ADDENDUM NO. 1

PROJECT NAME: CONVENTION CENTER PARKING LOTS PROJECT

DATE: 9/6/16

TCI PROJECT NO.: **42-00038**

CITY OF SAN ANTONIO
 CONVENTION & SPORTS FACILITIES
 YTURRI PARKING LOT REPAIRS PROJECT
 GRADING PLAN

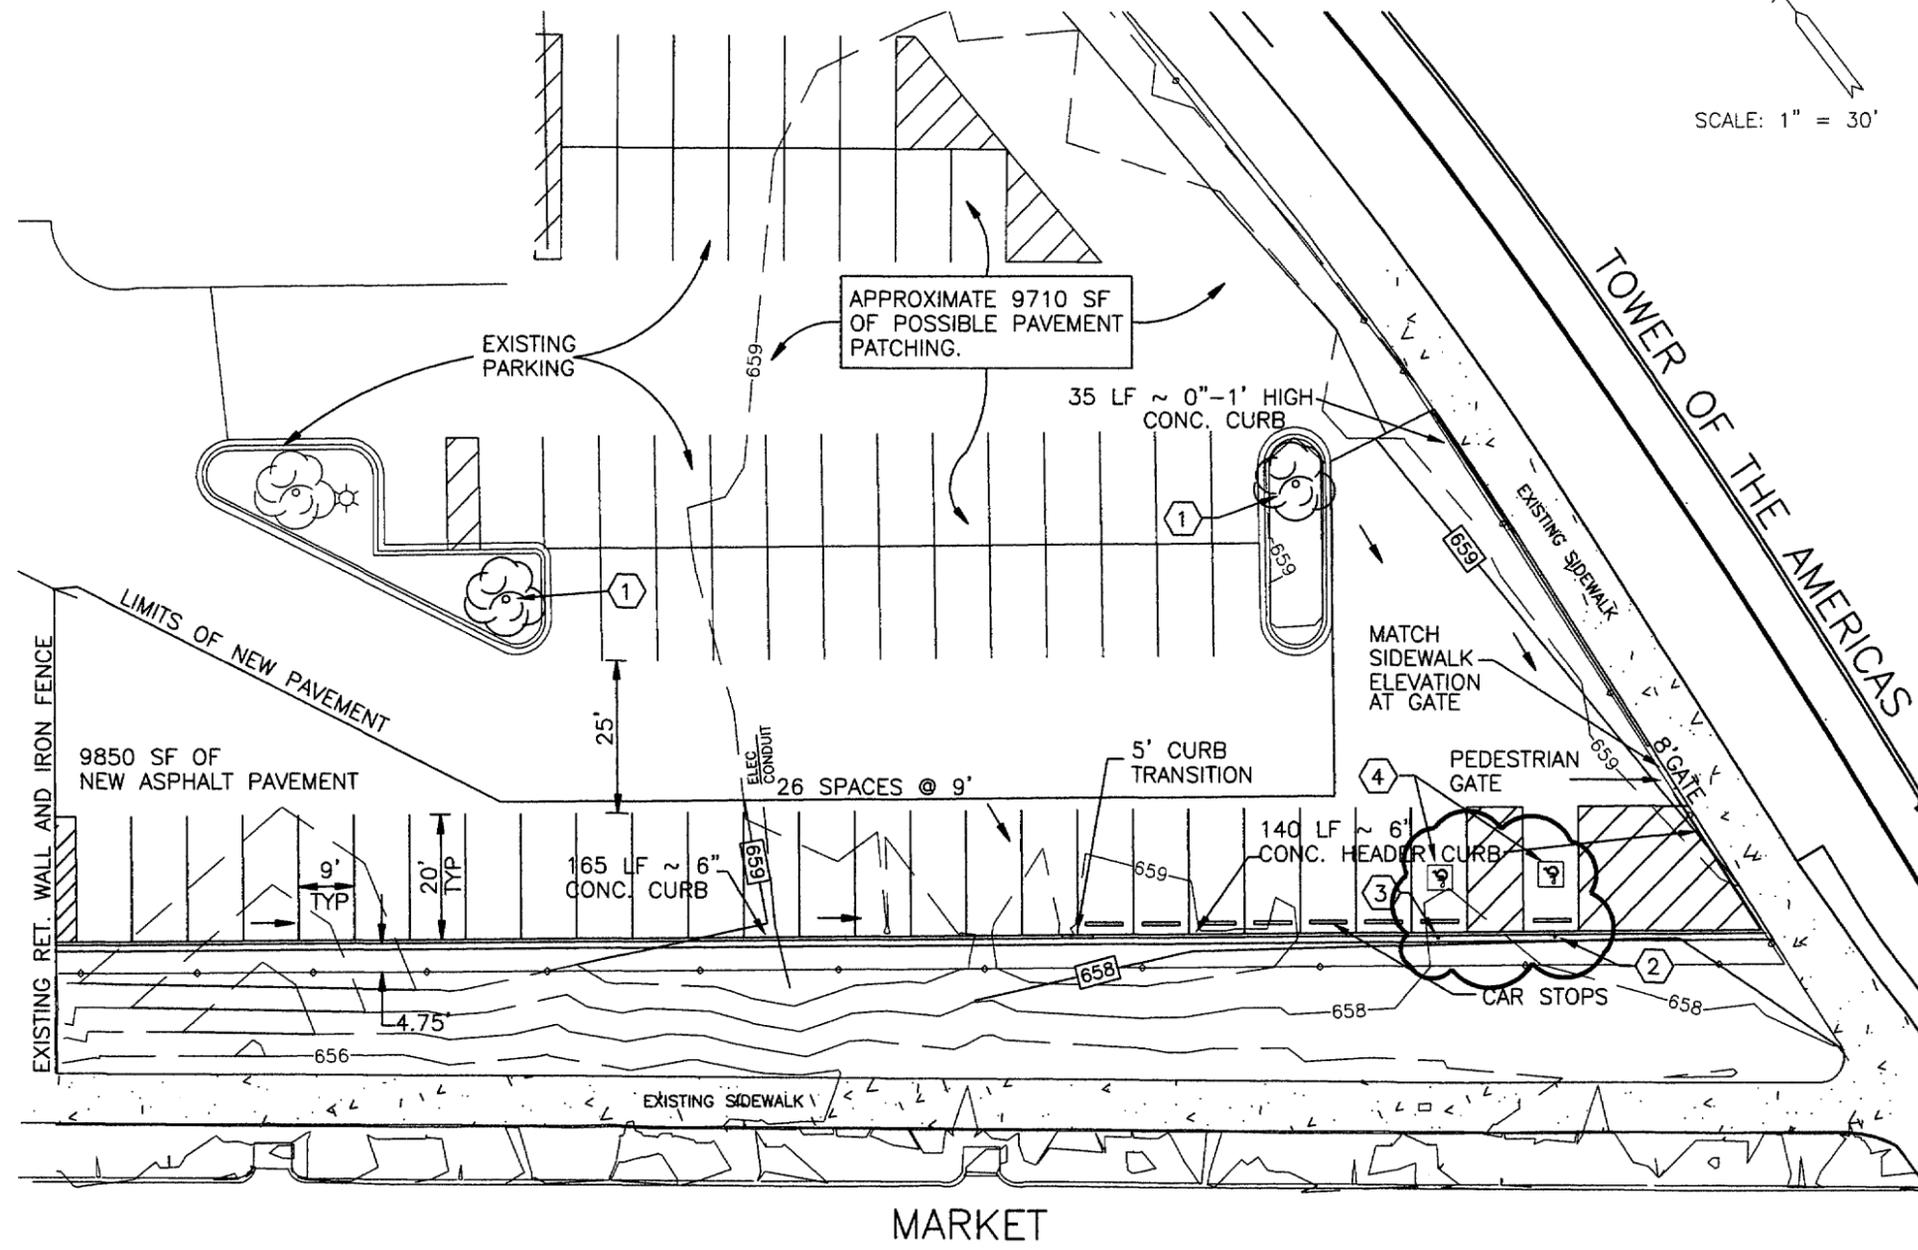
- Substitute “YTURRI PLANS & SPECIFICATIONS - Sheet 2 of 3” and replace with revised “YTURRI PLANS & SPECIFICATIONS – Sheet 2 of 3” as attached.

- Plans have been submitted to DSD for permits.
- Although there are no specific Landscape Plans for Yturri Lot, 2 new trees have been added on the Civil Plans. Use detail on the South Parking Lot for tree planting on Yturri Lot.

- 1 1 1/2" MEXICAN SYCAMORE TREES FOR PARKING SHADE. TO BE WATERED BY GATOR BAGS. SEE PLANTING DETAILS IN THE HBGCC SOUTH PARKING LOT PLANS.
- 2 HANDICAP VAN ACCESSIBLE PARKING SIGN - SEE DETAIL SHT C5.0 OF THE HBGCC SOUTH PARKING LOT PLANS.
- 3 HANDICAP ACCESSIBLE PARKING SIGN - SEE DETAIL SHT C5.0 OF THE HBGCC SOUTH PARKING LOT PLANS.
- 4 HANDICAP ACCESSIBLE PARKING SYMBOL PAVEMENT MARKING - SEE DETAIL SHT C5.0 OF THE HBGCC SOUTH PARKING LOT PLANS.

J.A.S.
 DRAWN BY:
 J.A.S.
 CHECKED BY:
 R.J.A.
 APPROVED BY:
 SEPT 2016
 DATE:
 REVISIONS
 1. ADDED ADA
 PARKING SIGNS &
 TREE DETAIL NOTE
 SHEET: 2
 OF: 3
